**NSLPP MEETING HELD 06/04/2022****SUPPLEMENTARY REPORT TO LPP 01 OF
NSLPP MEETING HELD 03/11/2021****Attachments:**

ADDRESS/WARD: 1 Baden Road, Kurraba Point**APPLICATION No:** DA 122/2021**PROPOSAL:** Demolition of all existing structures and construction of a part 4, part 5 storey dwelling house with an integrated garage, swimming and associated landscaping.**PLANS REF:**

OWNER: Laura Hazzouri and Charbel Hazzouri**APPLICANT:** Charbel Hazzouri C/- Revelop**AUTHOR:** Michael Stephens, Senior Assessment Officer**DATE OF REPORT:** 29 October 2021**DATE OF SUPPLEMENTARY REPORT:** 21 March 2021**DATE LODGED:** 4 May 2021**RECOMMENDATION:** Approval

Figure 1. Extract from written request of the proposed protrusions through the height plane

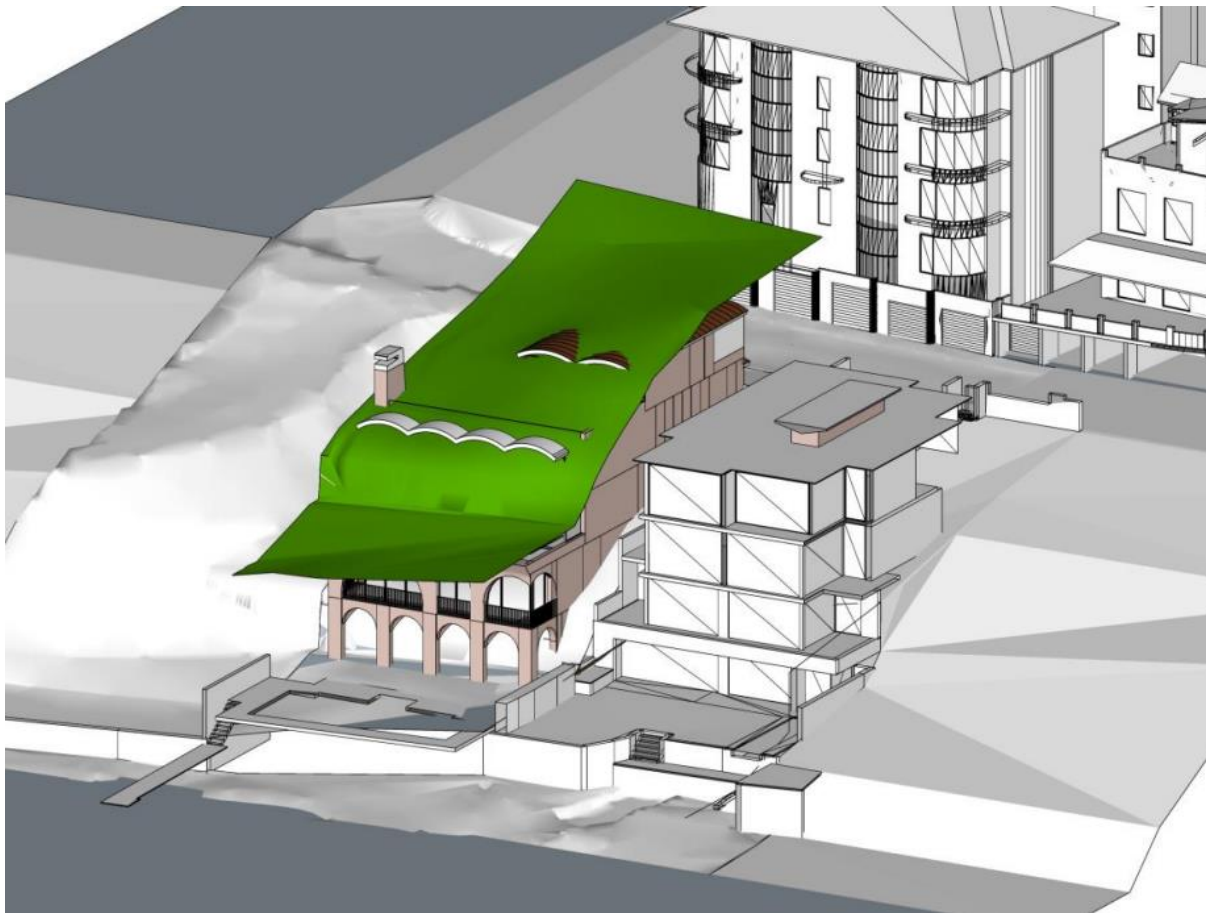
- (a) Fifth Level Roof Form – 470mm or 5.38%
- (b) Rear Roof Awning – 200mm or 2.35%
- (c) Glazed Balustrade - 600mm or 6.81%

It is noted that the chimney is exempt from the height of buildings definition in clause 1.4 in NSLEP 2013.

Figure 4. Extract from page 17 of the written request demonstrating the objectively net improvement to views from Unit 1 of No. 200 Kurraba Road

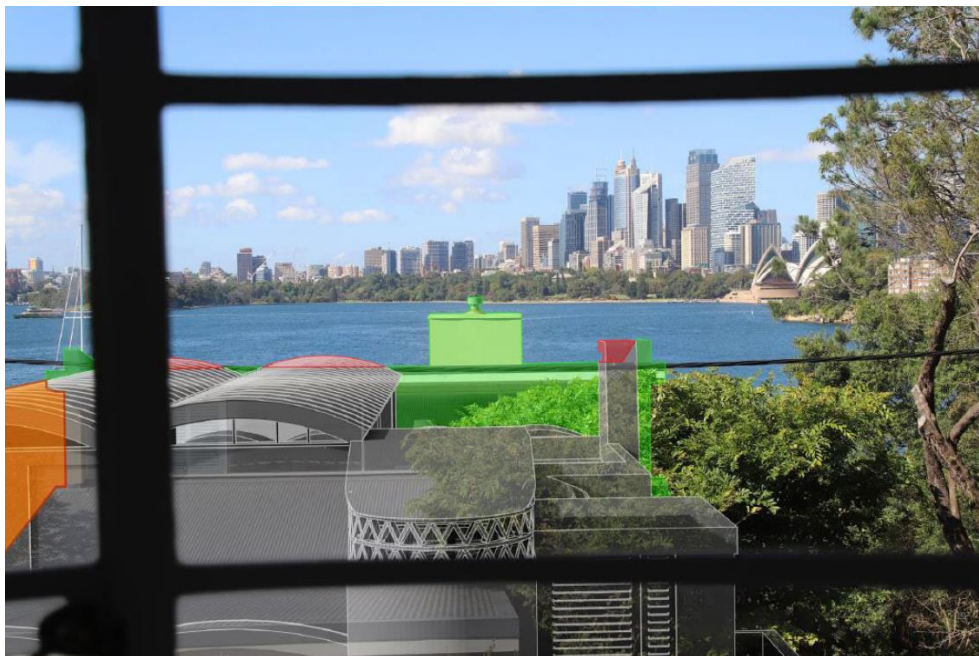
The second part of the objective states “*if appropriate, sharing of existing views,*” as discussed above, the proposed development is considered to reasonably promote the retention of views, notwithstanding, there are minor view impacts cause by the curved roof forms. Whilst this could be deemed acceptable in itself, the applicant’s written request has also noted that the proposed development also supports view sharing by reducing the extent of the existing impact caused by the existing dwelling by increasing the side setbacks of the proposed dwelling, particularly on the western side, and removing elements such as the chimney box which are reflected in **Figure 2.** below (*View from Unit 1 of No. 200 Kurraba Road - Page 17 – Attachment 3*). The impacts and improvements would also be similar when viewed from Unit 2 of No. 200 Kurraba Road.

Figure 5. Example of bedroom view

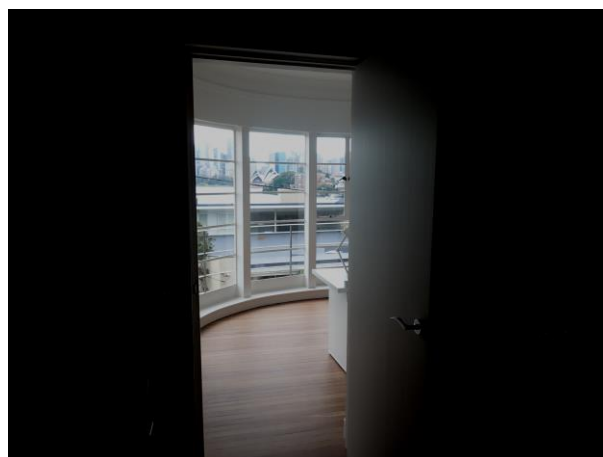
- *The view sharing analysis fails to account for views enjoyed from other rooms within the units of No. 2002 Kurraba Road such as bedrooms and bathrooms.*

Impacts to views from bedrooms and bathrooms are considered to be less significant as outlined in *Tenacity*. Nethertheless, it has been demonstrated that reasonable view sharing is achieved. It is noted that views from bedrooms and bathrooms are retained through the living areas (refer to the floor plans of Units 1 and 2 of No. 200 Kurraba Road on pages 25 and 29 of attachment 2) and are naturally less panoramic as they are obstructed by the internal walls of the units, however, any potential view impact remains minimal.

Figure 4. Extract from page 17 of the written request demonstrating the objectively net improvement to views from Unit 1 of No. 200 Kurraba Road

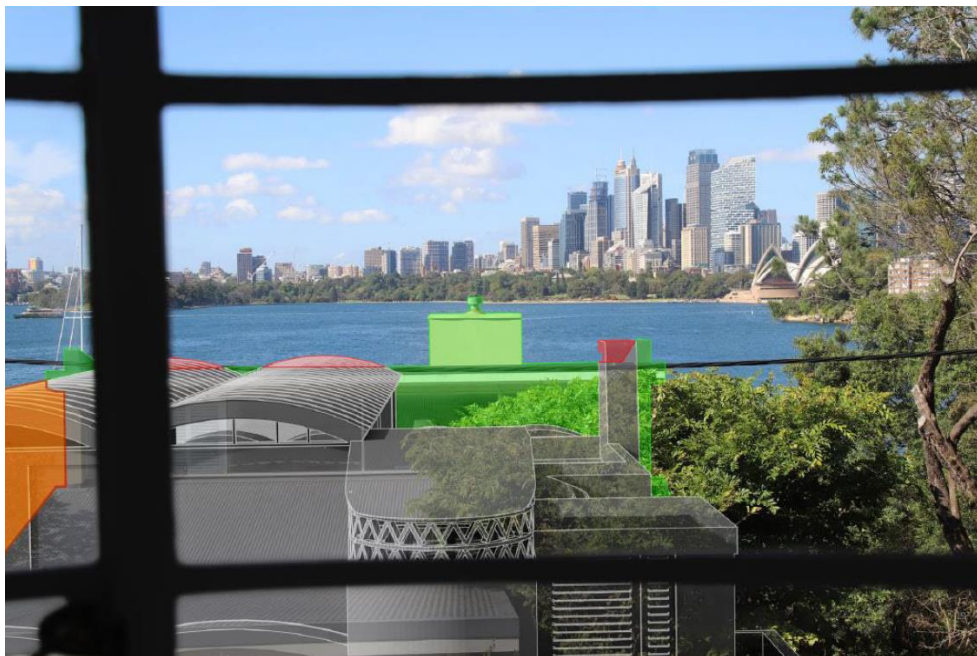
The second part of the objective states “*if appropriate, sharing of existing views,*” as discussed above, the proposed development is considered to reasonably promote the retention of views, notwithstanding, there are minor view impacts cause by the curved roof forms. Whilst this could be deemed acceptable in itself, the applicant’s written request has also noted that the proposed development also supports view sharing by reducing the extent of the existing impact caused by the existing dwelling by increasing the side setbacks of the proposed dwelling, particularly on the western side, and removing elements such as the chimney box which are reflected in **Figure 2.** below (*View from Unit 1 of No. 200 Kurraba Road - Page 17 – Attachment 3*). The impacts and improvements would also be similar when viewed from Unit 2 of No. 200 Kurraba Road.

Figure 5. Example of bedroom view

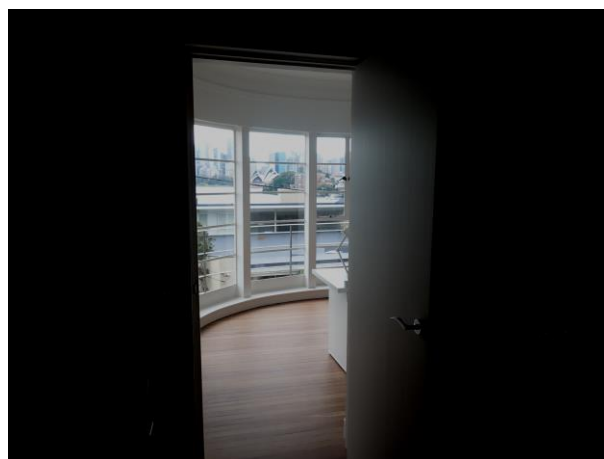
- *The view sharing analysis fails to account for views enjoyed from other rooms within the units of No. 2002 Kurraba Road such as bedrooms and bathrooms.*

Impacts to views from bedrooms and bathrooms are considered to be less significant as outlined in *Tenacity*. Nethertheless, it has been demonstrated that reasonable view sharing is achieved. It is noted that views from bedrooms and bathrooms are retained through the living areas (refer to the floor plans of Units 1 and 2 of No. 200 Kurraba Road on pages 25 and 29 of attachment 2) and are naturally less panoramic as they are obstructed by the internal walls of the units, however, any potential view impact remains minimal.
